**AUTOTRANSFORMER-TYPE STARTERS**  
**AND COMPENSATORS**  
**GENERAL ELECTRIC COMPANY**  
**REQUIREMENTS AND ADJUSTING PROCEDURES**

**1.001** This addendum supplements Section 026-305-701, Issue 10. The attached pages must be inserted in the section in accordance with the filing instructions above.

**1.002** This section is reissued to revise Fig. 36.

Fig. 36 — KS-15941 Starter Schematic — L1 to L7 (220 Volt) and L11 to L17 (440 Volt)

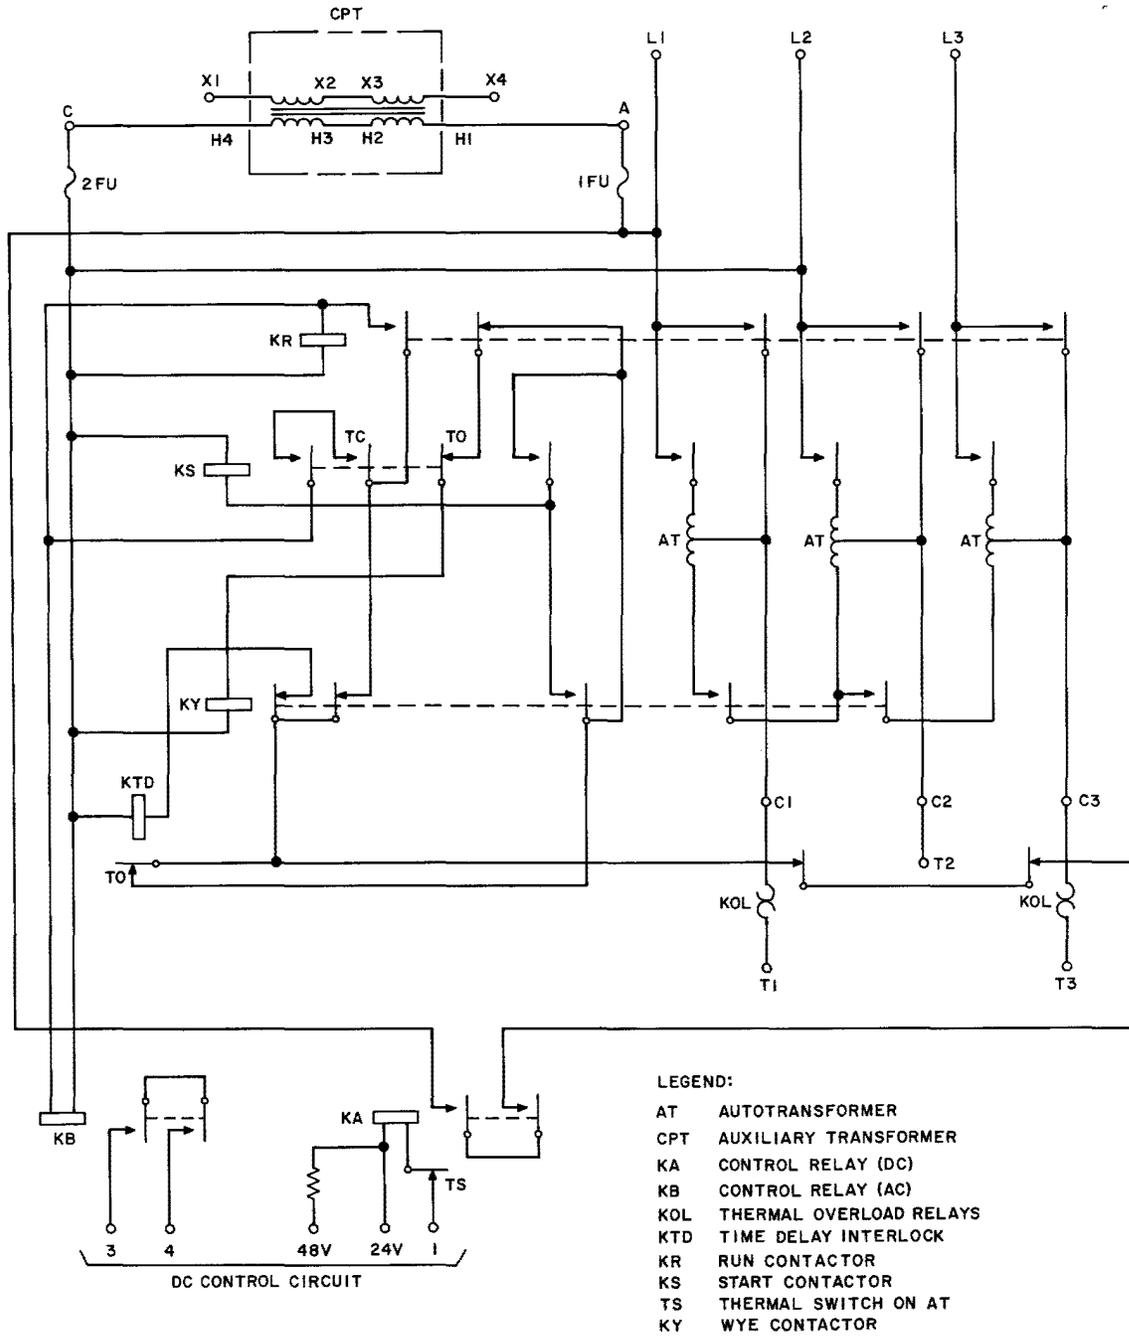
(a) Fig. 36 — revised.
